Docket No. 52-001

SUBJECT: FINAL REPORT TO DOCUMENT THE DISPOSITION OF THE IIRG COMMENTS
ON THE GE NUCLEAR ENERGY (GE) ADVANCED BOILING WATER REACTOR
(ABWR) INSPECTIONS, TESTS, ANALYSES, AND ACCEPTANCE CRITERIA
(ITAAC)

INDEPENDENT REVIEW GROUP COMMENTS REQUIRING DISPOSITION BY GE

FIGURE 15E-2 ATWS MITIGATION LOGIC (ELCS INITIATION, FEEDWATER RUNBACK)

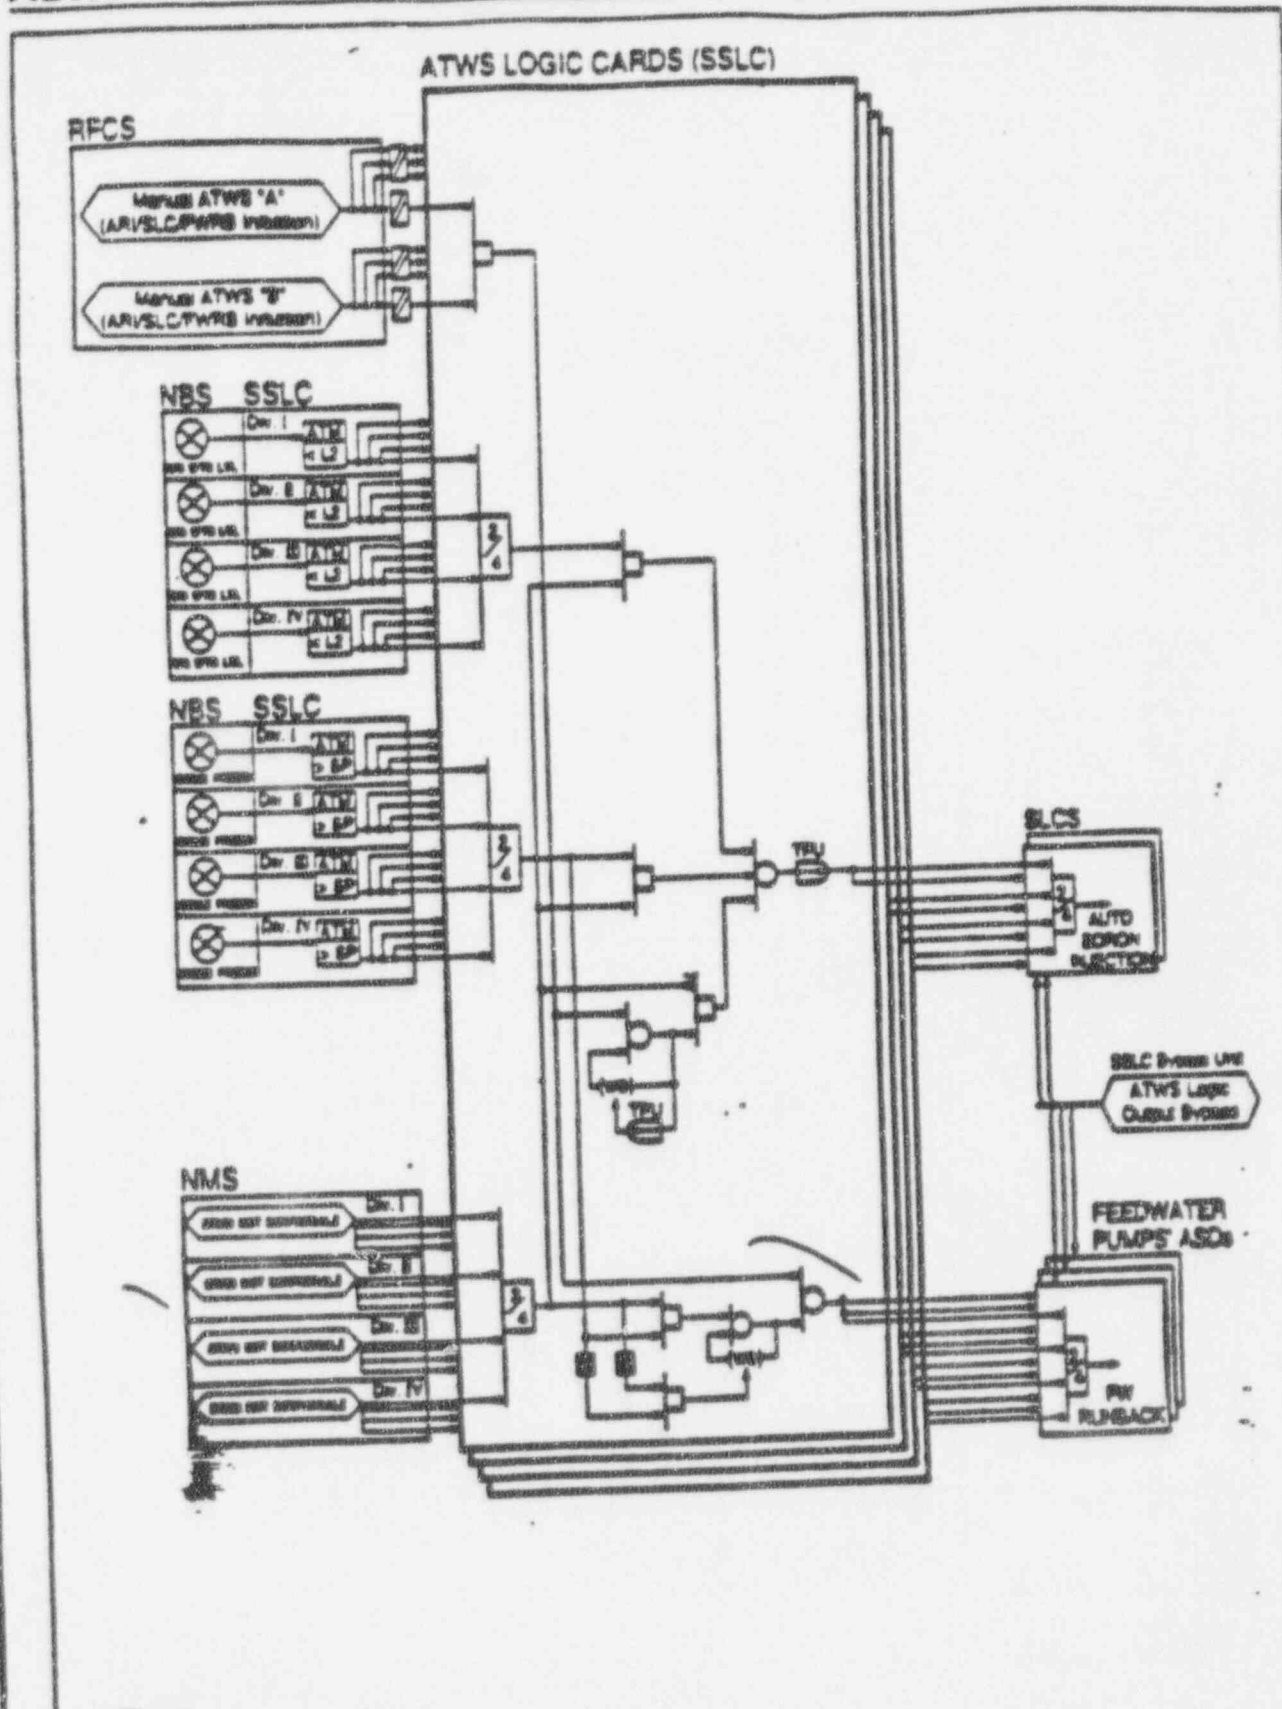
Figure 15E-1 ATWS mitigation logic indicates that the SB&PC system provides the steam dome pressure input to the RFC system. Per the system descriptions, the APR system is the RFC interface for the SB&PC system. See CDM 2.2.9 and 2.2.10 attached.

The title of figure 15E-2 is not consistent with the title of figure 15E-1. See SSAR, page 15E-18.

GE does not believe there are any inconsistencies requiring CDM changes. The SB&PC does in fact provide pressure signals to the RFC System for ATWS logic as shown on SSAR Figure 15E-1 and CDM Figures 2.2.8 and 2.2.10. The APR/RFC interface shown on Figure 2.2.9 is associated with the APR control function and is input to RFC for reactor power regulation (via flow control).

Figure 2.4.4a Reactor Core Isolation Cooling System

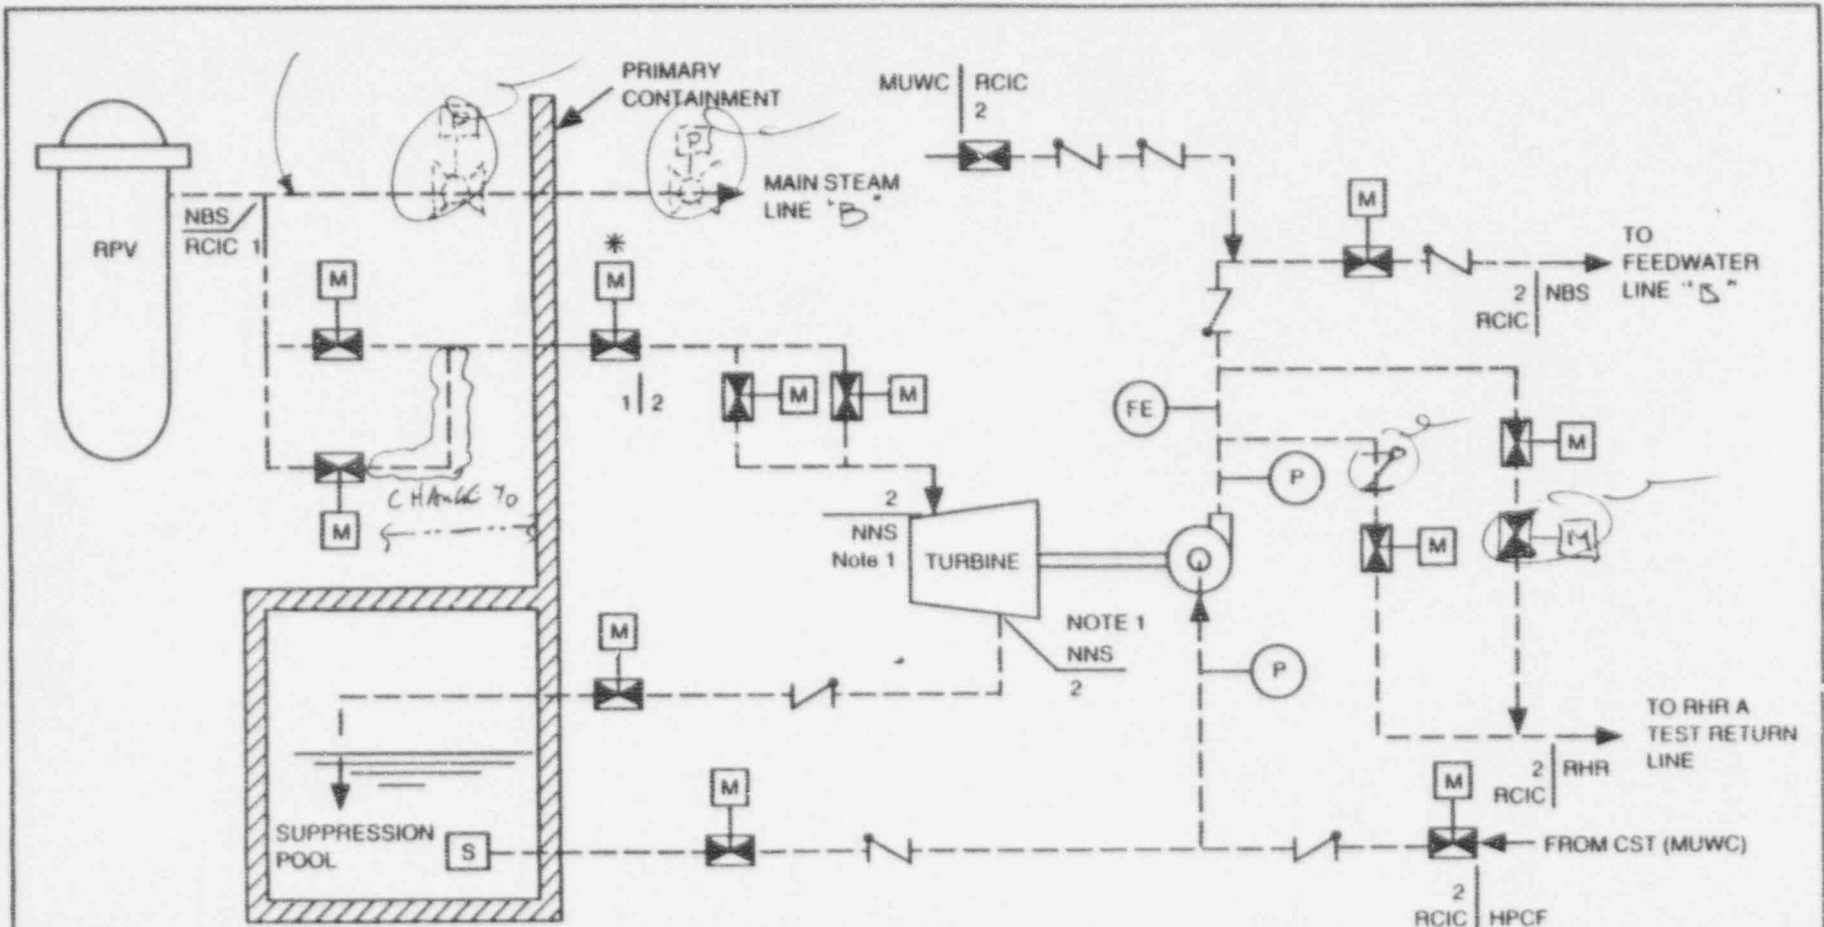
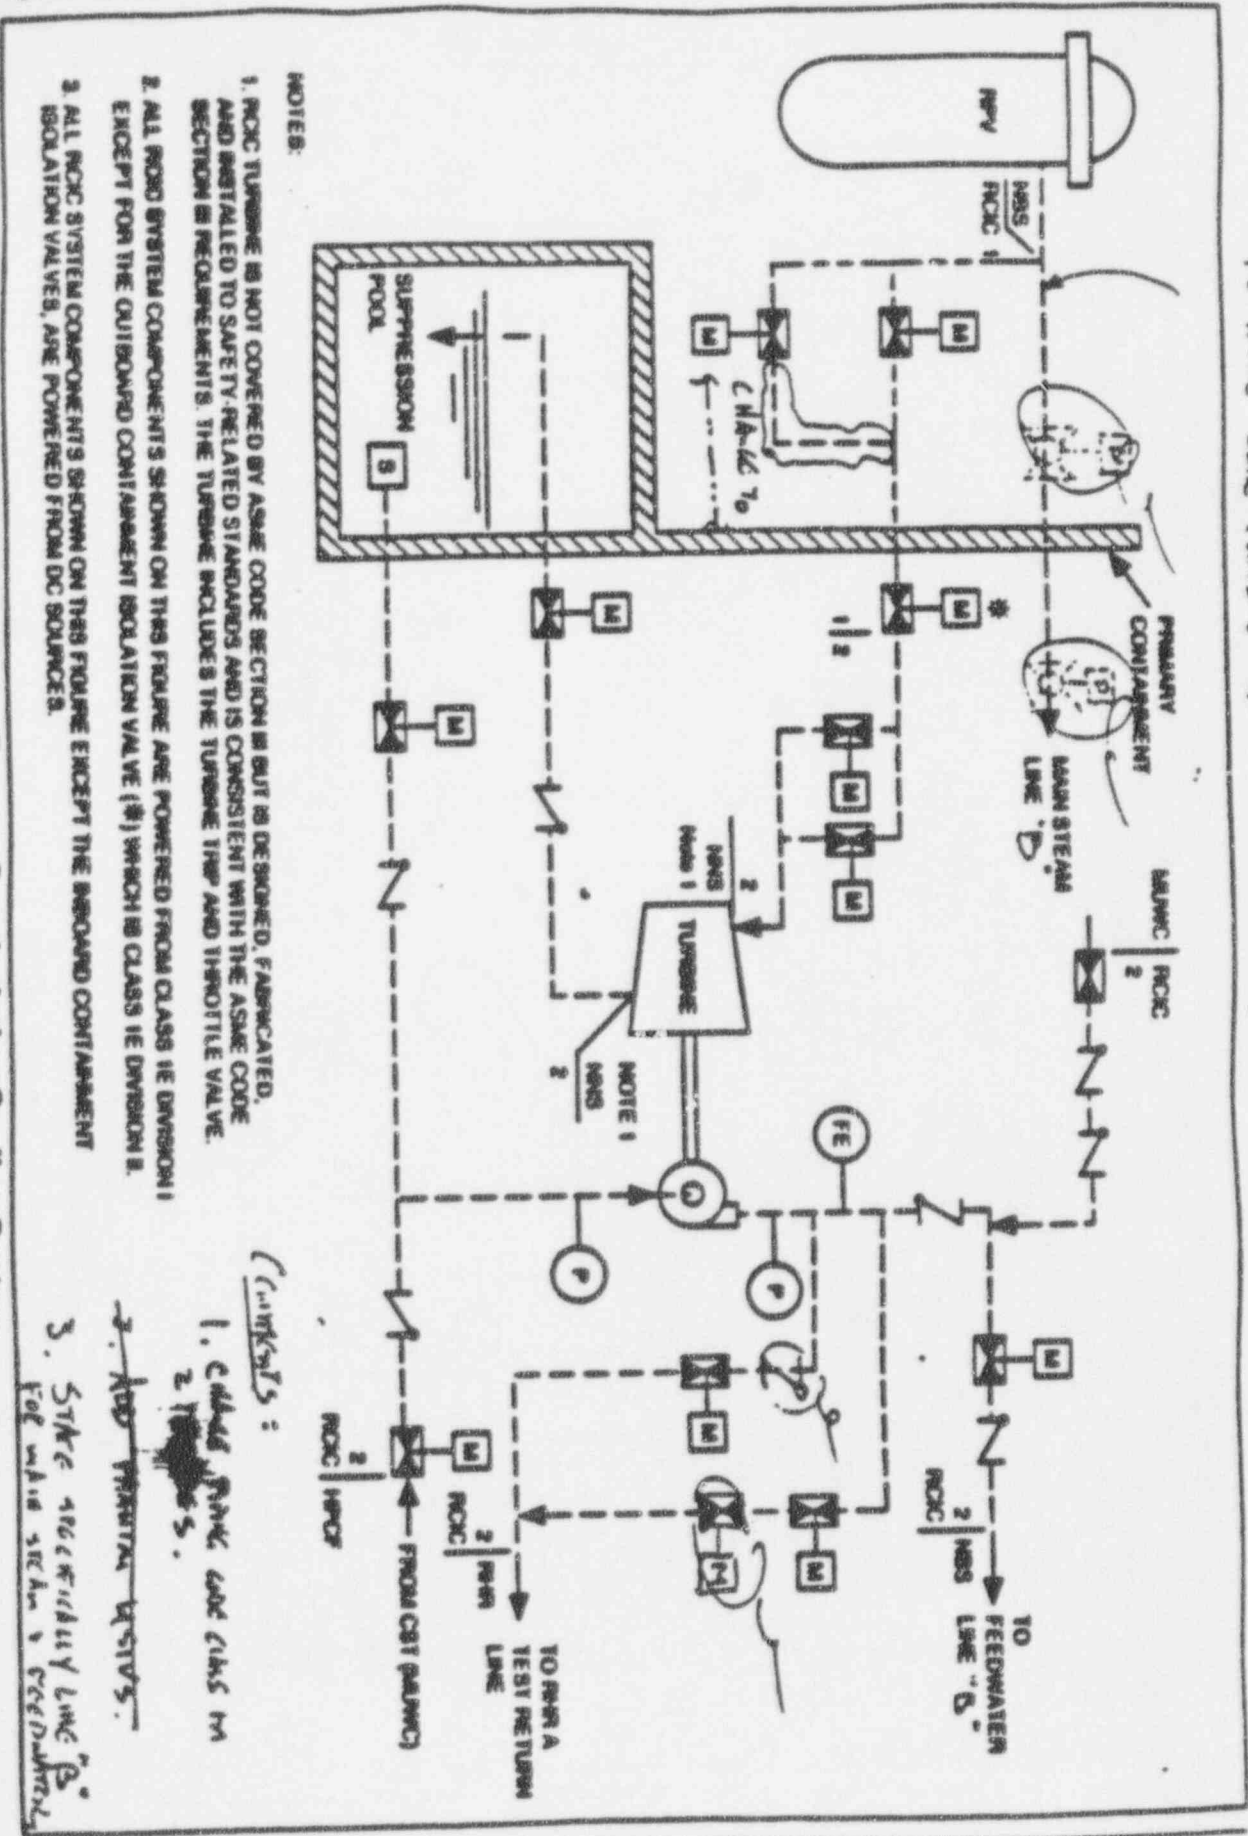
(1) Figure 2.4.4a: Main Steam line is "out of function" in this Figure. But the lines are misleading since the ASME class 2 designation symbol is used. Use different symbols to indicate "out of function" systems.

(2) Figure 2.4.4a: Add "B" to "Main steam line"

(3) Figure 2.4.4a RCIC steam supply line bypass valve line from the outlet to the main line is shown incorrectly. This should be shown as ASME class 1.

See comments on attached copy of Figure 2.4.4a.

LINE NBS (70A RV) TO ADD/DID HGV
IS ASME CLASS 1
